Addendum #3

Mecklenburg County, North Carolina

Solicitation # 487 – MRF Operations

- This Addendum revises the Interim/C&D MRF Operations Proposal (RFP) and MRF Operations Qualifications (RFQ) by including the Responses to Bidder Questions.

DRAWING TITLE:
EQUIPMENT PROCESS FLOW DIAGRAM

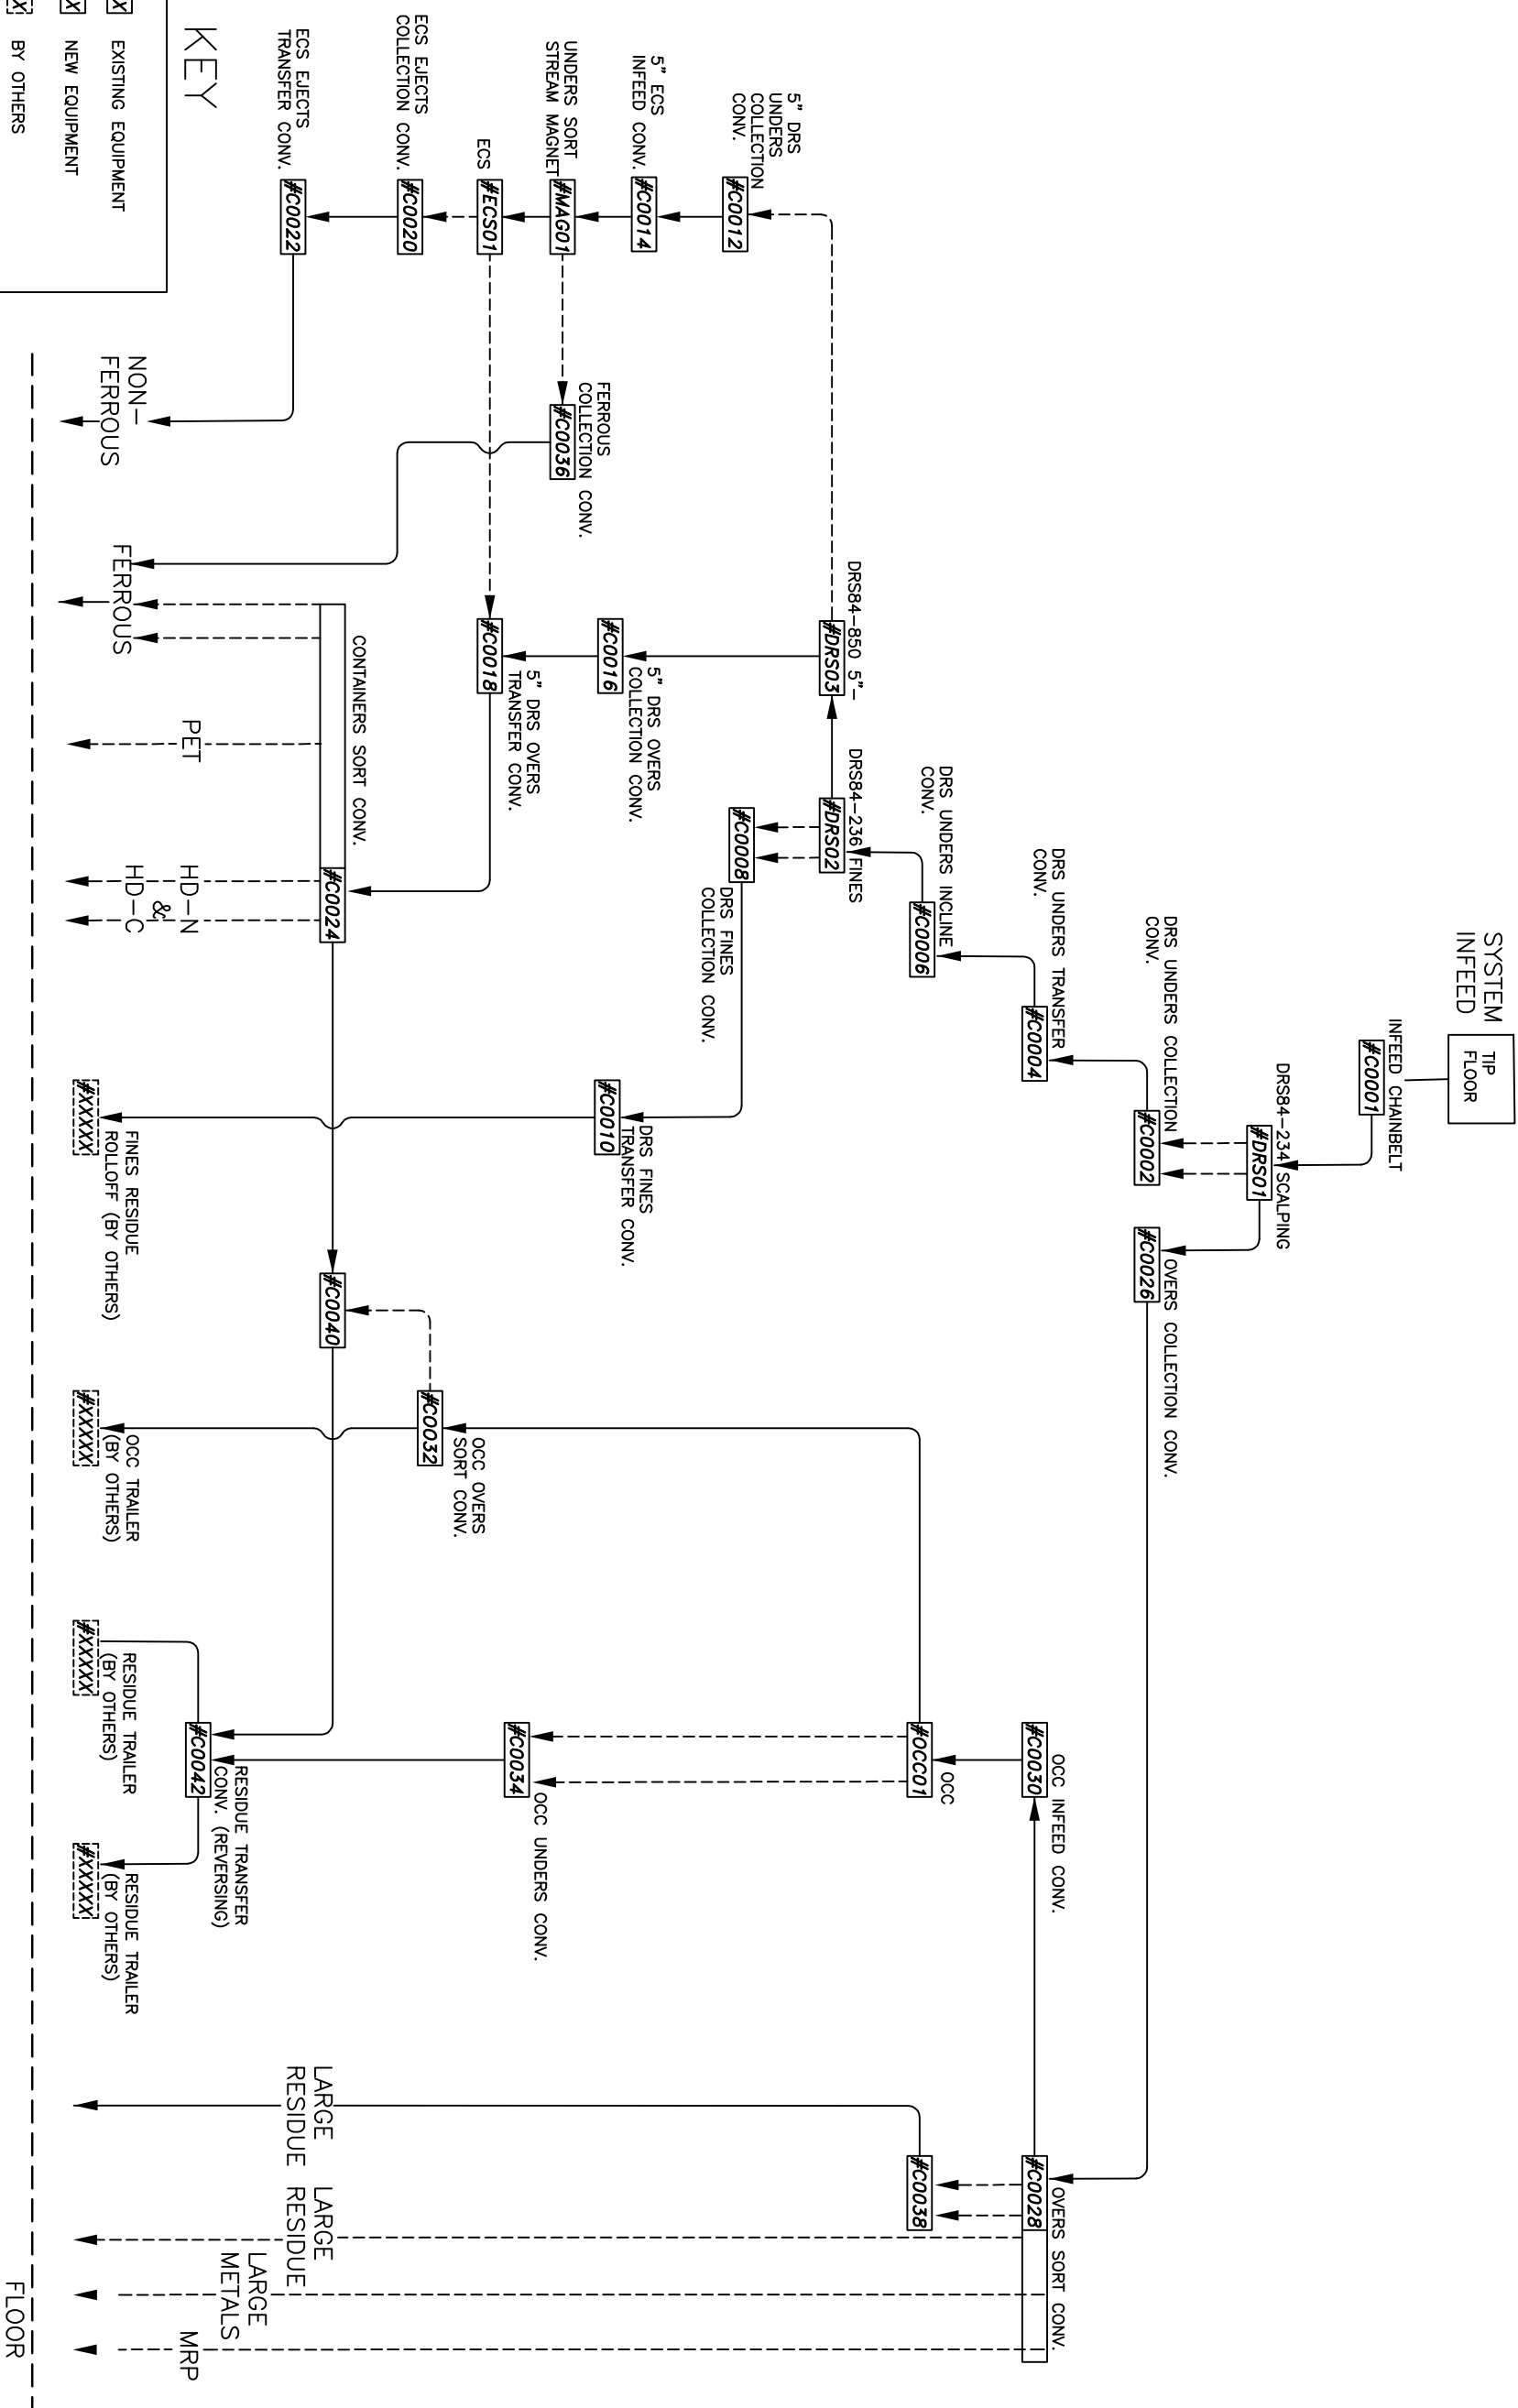
- Material flow diagram for the system per manufacturer's specifications. We are interested in understanding throughput and capture rate, by grade, for each material type.

See attached Bulk Handling System Equipment Process Flow diagram. The design throughput is 40 tons per hour. The attached table titled "2310 Mecklenburg County" provides the recovery percentages for recyclable materials. OCC, Ferrous & Non-Ferrous materials are sorted by equipment. All other recyclable materials are manually sorted.
